AMENDED

PROJECT: Ravenscar Tearooms
1 Station Sq Ravenscar

Drawing: Rebuild existing Lean-to
Existing and Proposed
Plans and Elevations

DRAWING No: D11185-02
REV: D

Part Ground Floor Plan
Scale 1:50

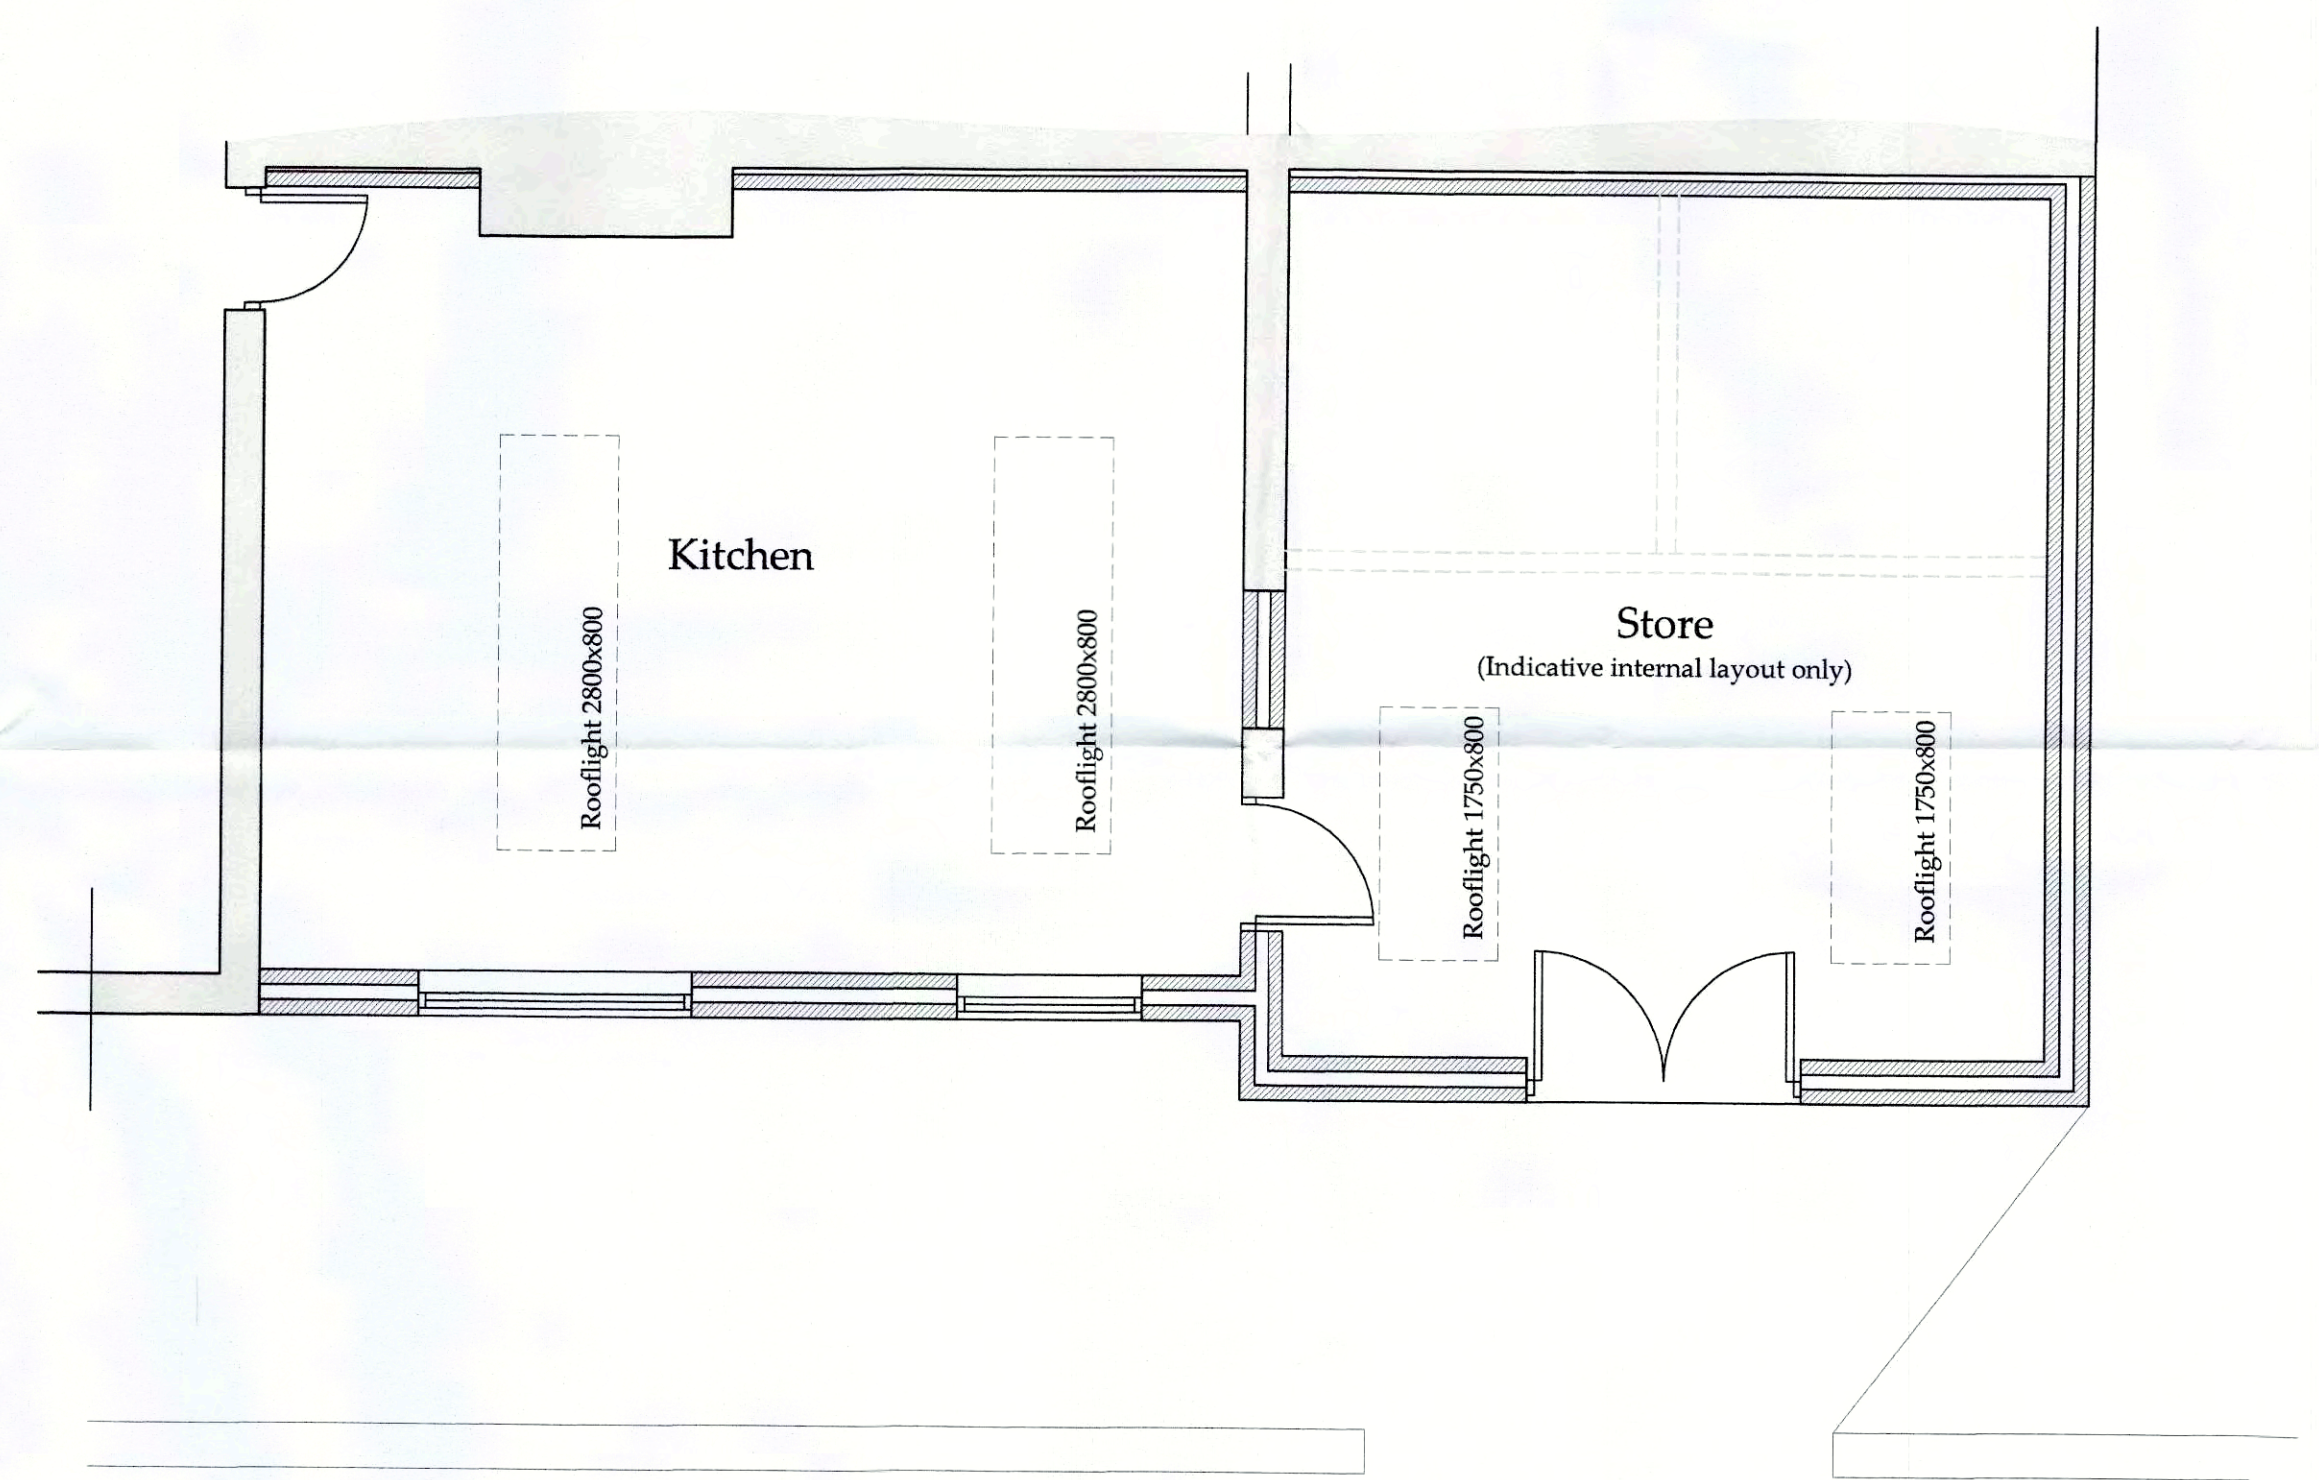
D	19/07/17	NID	Set back kitchen
C	22/06/17	nld	rooflight reduction and doors
B	22/05/17	nld	Client amends
A	08/05/17	CE	Issued for approval
